Keithley Instruments  
28775 Aurora Road  
Cleveland, Ohio 44139  
1-800-833-9200  
[tek.com/keithley](http://tek.com/keithley)

This firmware is used on the following Keithley Instruments product models:

- Model 2460 High-Current Interactive SourceMeter® Instrument
- 2460-NFP
- 2460-RACK
- 2460-NFP-RACK

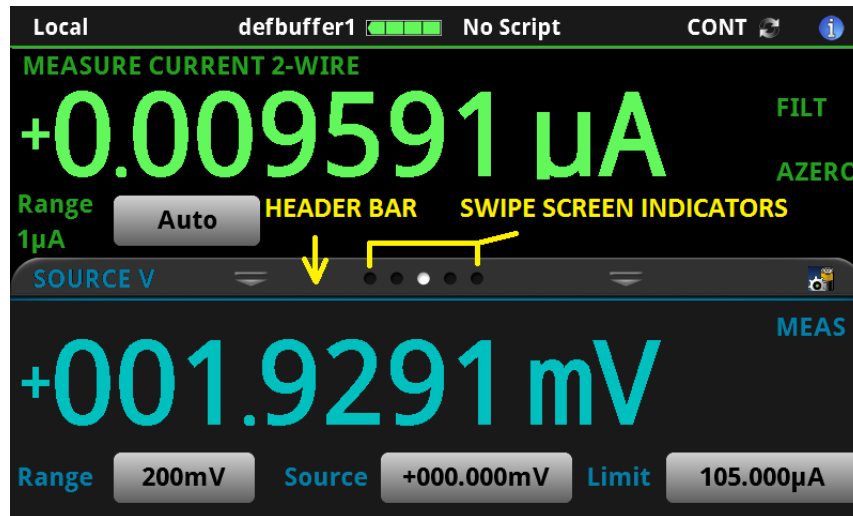
1. Screen Colors: All screen colors have been modified for better contrast and easier readability.
2. Pinch-to-Zoom Performance: Throughout the user interface, the “Pinch-to-zoom” touch screen motion has been improved and is more responsive.
3. Improve Swiping:
  - a. The swipe user interface gesturing has been dramatically improved and is more responsive.
  - b. Added Vertical Swiping in various screens in the GUI.
  - c. Horizontal swiping has been made more smooth and is consistent with Vertical Swiping.
  - d. “Fling” swiping has been implemented where faster swiping actions result in rapid scrolling followed by decay based on the velocity of the “fling.”
  - e. Swipe Down on the Home screen will display larger readings.

4. Tabs and Buttons: Throughout the user interface multiple data display options have been made available through tabs (header bars) with swipe screen indicators to show how many different display options are available and which display tab is active.
